Stakeholder Comments

Frequency Response Ph 2 2/9/2017 Meeting

Submitted by	Company	Date Submitted
Aditya Chauhan – (626) 302-3764	Southern California Edison	February 23, 2017

Southern California Edison (SCE) offers the following comments on the 2/9/2017 Frequency Response Ph 2 Meeting¹ of the California Independent System Operator (CAISO).

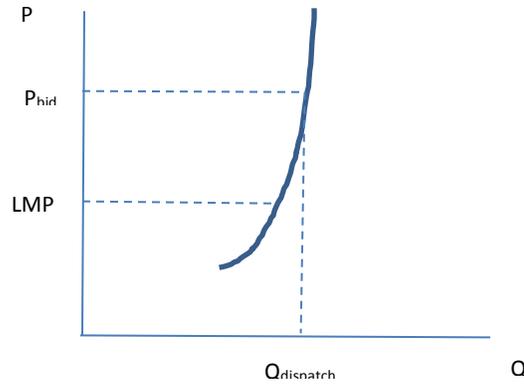
Regarding market power, consider a FR-dispatched resource with the following bid curve:

SCE asks the CAISO to clarify if such a resource would receive Bid Cost Recovery (BCR) in a circumstance where they deviated due to a frequency response event where the quantity delivered placed the resource on a point of its bid curve that is above the market clearing price. If such a resource will receive BCR, SCE asks that the CAISO clarify how it will mitigate potential market power.
